8/9.9 HP FourStroke Remote Control Cable Attaching Point Models Affected

Models Covered	Model Number
Mercury/Mariner 8/9.9 HP Remote Control FourStroke Outboards	1F10204HV
	1F10312HK
	1F10352HK
	1F10452HK
	1F10462HK
	7F10312ZK
	1F10312HA
	7F10312ZA
	1B08312HB

29569

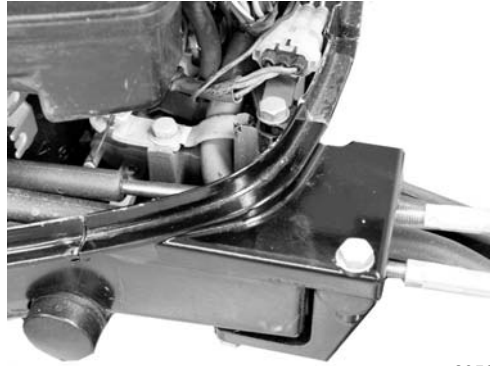
Beginning with outboard models released in July of 2007, all 8/9.9 HP FourStroke outboards will accept Mercury Marine barrel type control cables.

- a** - Remote control cable stay
- b** - Cable barrel
- c** - Remote control harness
- d** - Grommet
- e** - Throttle cable
- f** - Shift cable
- g** - Washer (2)
- h** - Retainer clip (2)

29341

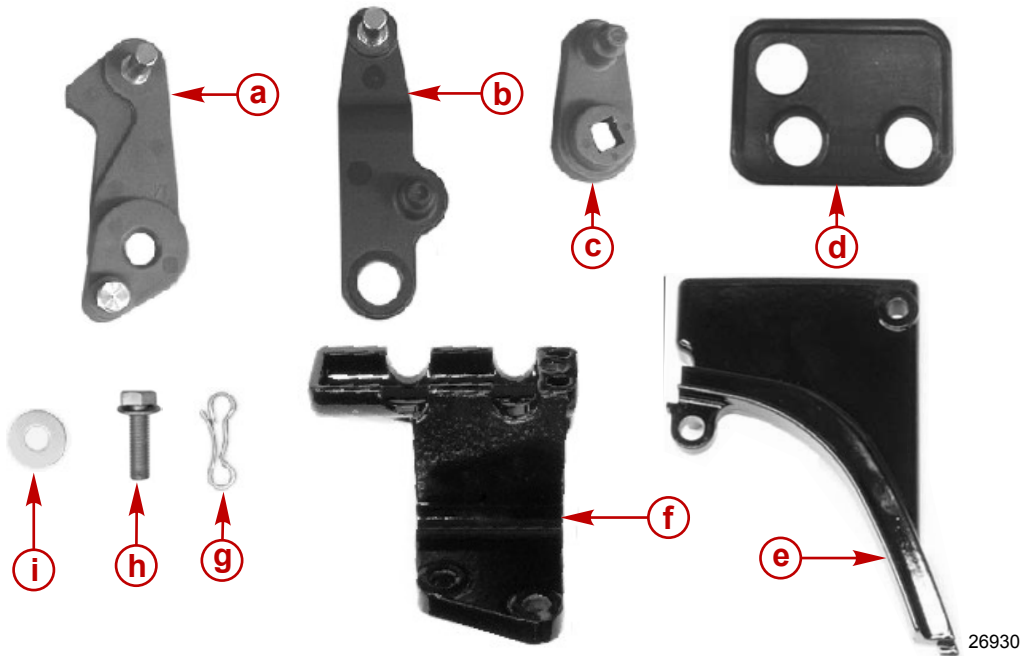
Mercury Marine will offer two kits to address boats or engines that do not have compatible throttle and shift cables:

1. Kit P/N 64-892790A01 will allow boats rigged with SAE cable connectors to hook up to the new style engines which require Mercury Marine barrel connections.
